FEBRUARY 17 1978

The Commission has issued the enclosed Amendments Nos. 59, 59 and 56 for License Nos. DPR-38, DPR-47 and DPR-55 for the Oconee Nuclear Station, Unit Nos. 1, 2 and 3. These amendments consist of changes to the Station's common Technical Specifications and are in response to your request dated January 23, 1978.

These amendments revise the Oconee Nuclear Station's common Technical Specifications to allow Cycle 4 operation of Oconee Unit No. 1 past 100 effective full power days.

SAFETY EVALUATION BY THE OFFICE OF NUCLEAR REACTOR REGULATION

OCONEE 1 CYCLE 4 ROD POSITION  
LIMITS FOR FOUR PUMP OPERATION  
AFTER 100 ± 10 EFPD

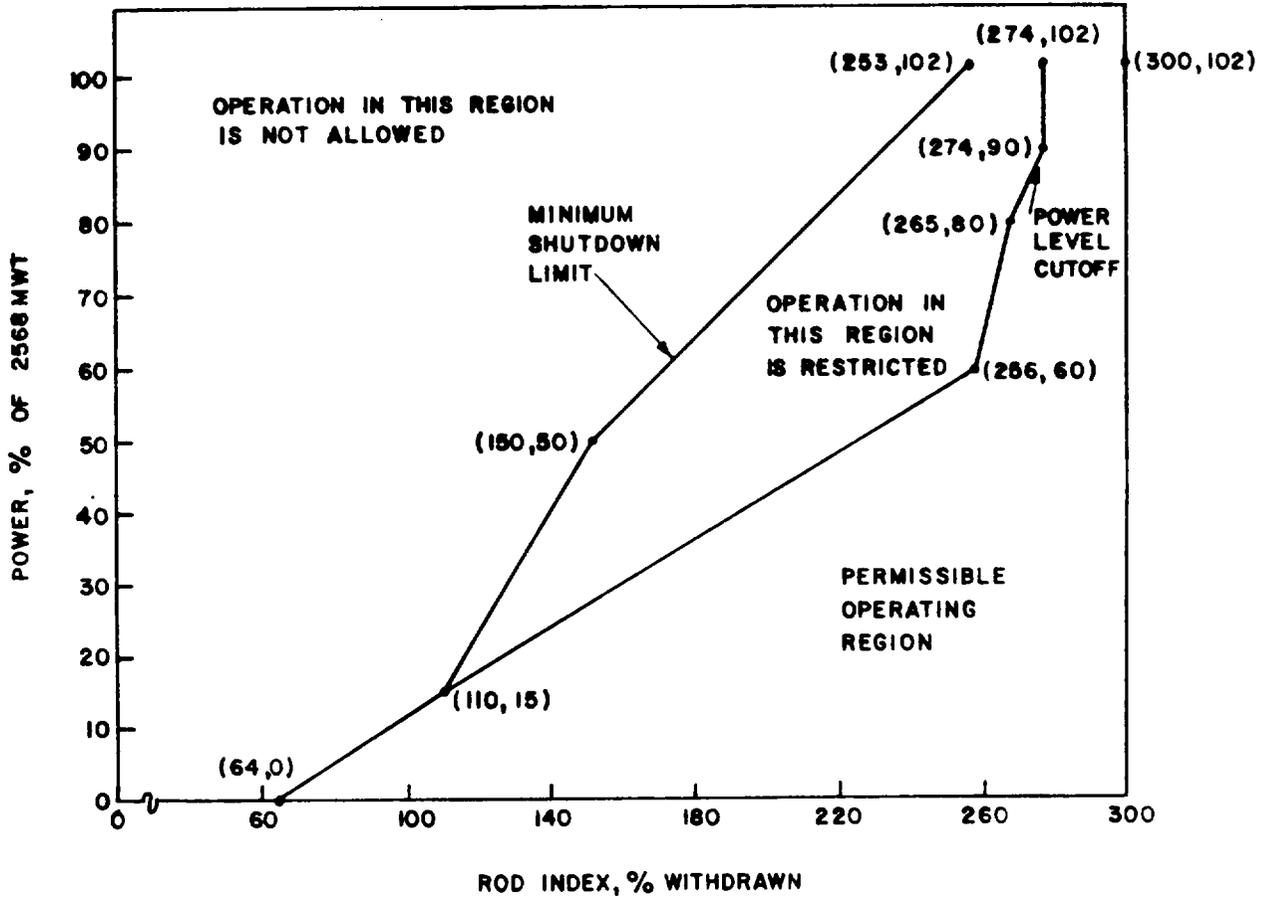
By letter dated January 23, 1978, the licensee proposed revised control rod position and axial power imbalance Technical Specifications limits for the period from 100 EFPD to end-of-cycle (EOC). These revised limits considered actual core performance with the tilt. The licensee also presented a discussion and calculation on the possibility that the observed tilt in Cycle 4 could have been caused by a small tilt in Cycle 3 and the cross-core shuffling of once and twice burned fuel for the Cycle 4 design.

The ejected rod worth insertion limits were determined in an extremely conservative fashion. The Hot Full Power (HFP) ejected rod worth limits were based on projected EOC data and were still found to be less limiting than the shutdown margin insertion limits. At Hot Zero Power (HZP) the 0-100 EFPD rod insertion limits were adjusted based on a projected slight increase in the maximum ejected rod worth at EOC. The resulting rod insertion limits were less limiting than shutdown margin criteria at all power levels above zero power. Thus only the zero power limit (64% withdrawn) is based on ejected rod criteria.

The shutdown rod insertion limits were determined using standard techniques based on symmetric conditions and adjusting these calculations to account for the tilt. The calculated stuck rod worths were increased 10%.

Figure 3.5.2-3A1

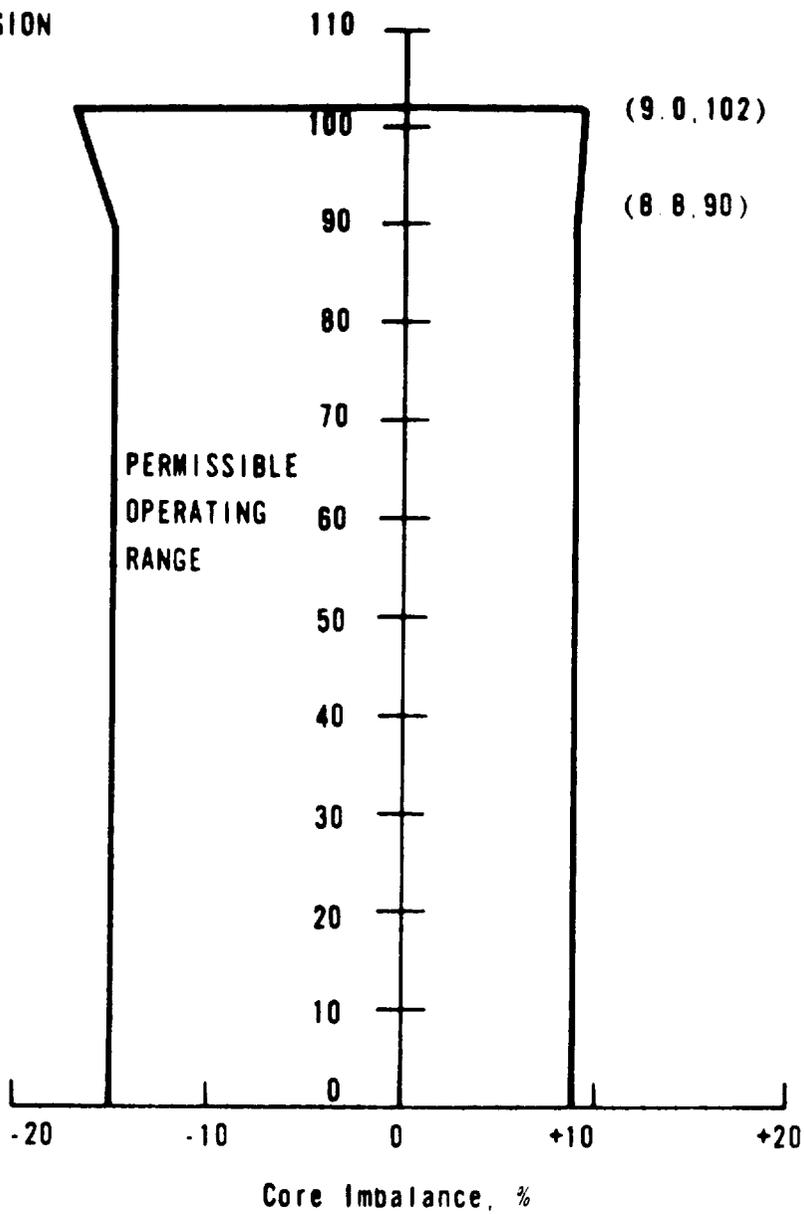
3.5.2.6 Reactor power imbalance shall be monitored on a frequency not to exceed two hours during power operation above 40 percent rated power. Except for physics tests, imbalance shall be maintained within the envelope defined by Figures 3.5.2-3A1, 3.5.2-3B1, 3.5.2-3B2, 3.5.2-3B3, 3.5.2-3C1, 3.5.2-3C2, and 3.5.2-3C3. If the imbalance is not within the envelope defined by these figures, corrective measures shall be taken to achieve an acceptable imbalance. If an acceptable imbalance is not achieved within two hours, reactor power shall be reduced until imbalance limits are met.

Figure 3.5.2-4A2

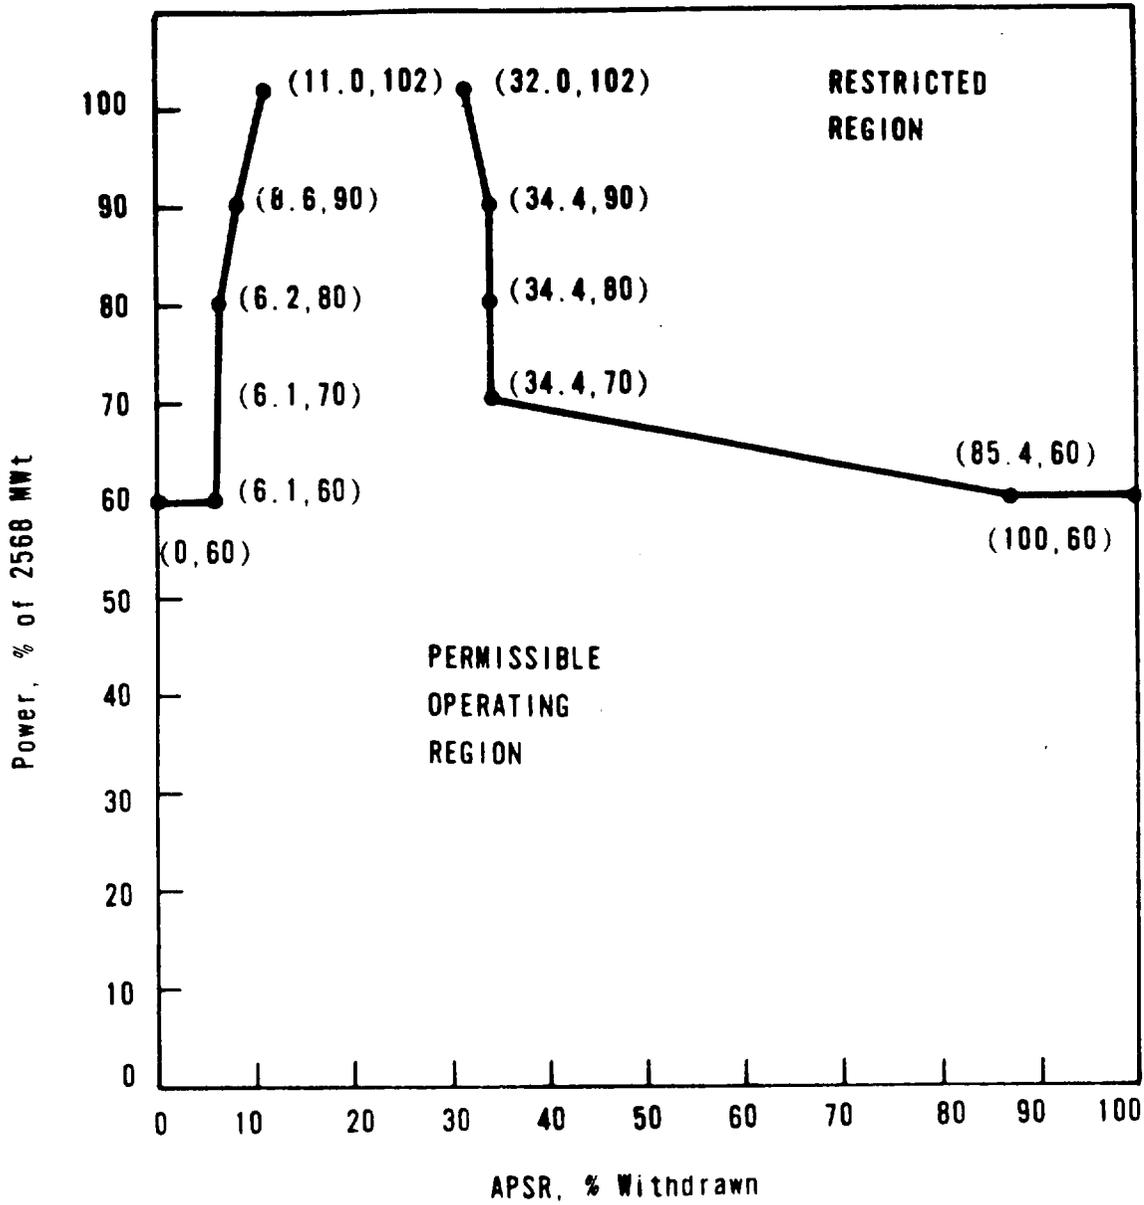
The net effect of all these conservatisms is that the core will be restricted in operating flexibility but allowed to operate at full power in a safe manner. The APSR position limits, Technical Specification Figure 3.5.2 - 4A3, originally approved for operation after  $235 \pm 10$  EFPD should be observed after  $100 \pm 10$  EFPD. The imbalance limits that are currently in force for 0 to 100 EFPD are more restrictive than necessary for the proposed mode of rods-out operation from 100 EFPD to EOC, and can thus be retained. This represents another conservatism in the analysis. The rod position limits were determined based on the super-position of the most conservative calculated and measured data. On these bases, the staff finds the proposed changes to the Oconee Unit 1 Technical Specifications to be acceptable.
